Site Control Modification Manual 14H Update

Markets and Reliability Committee
November 21, 2024

Exhibit 10: Generator Interconnection into Existing TO Substation

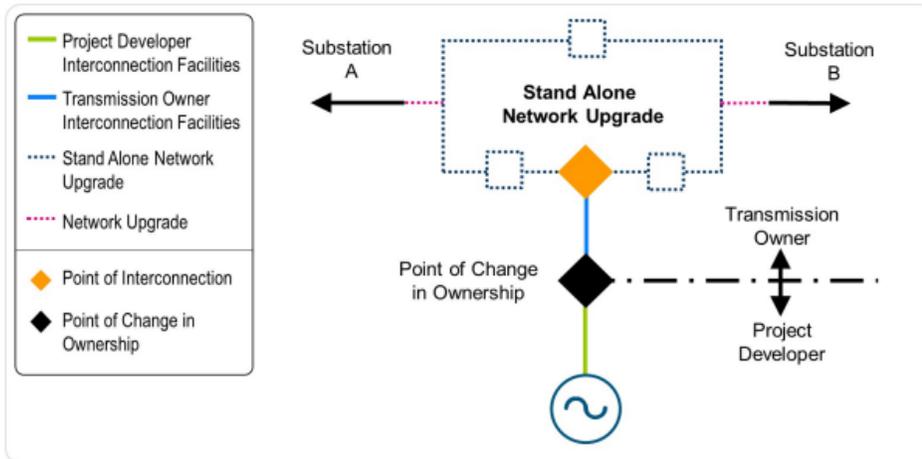
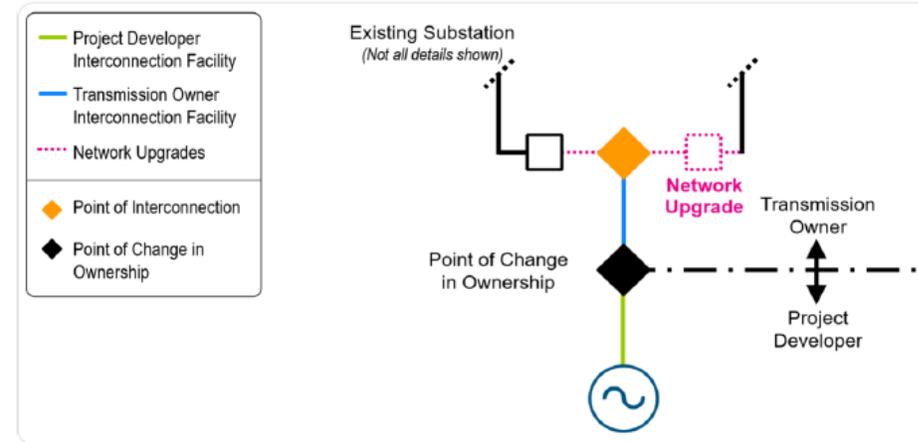
- In M-14H Section 4.9 shows diagrams of typical New Service Request Connection Types
- Exhibit 9 shows “Generator Interconnection via New Interconnection Switchyard”
- Exhibit 10 is supposed to show “Generator Interconnection into Existing TO Substation” but instead is the same diagram used in Exhibit 9

- PJM seeks to correct Exhibit 10
- PJM seeks to provide greater clarification on how Developers can meet tariff requirements for Site Control and what Site modifications are allowed under the tariff
- As PJM continues progress through TC1 and TC2 applications are due in Q4 2024, it is important for Developers to understand what Site Control modifications are allowed under the tariff in order to be able to continue to develop their projects and meet tariff requirements for Site Control at various points of the Interconnection Cycle process

4.9.2 Generator Interconnection into Existing Transmission Owner's Substation
 Exhibit (Generator Interconnection into Existing TO Substation) depicts a generator interconnecting to an existing Transmission Owner substation which needs to be expanded to accommodate the interconnection.
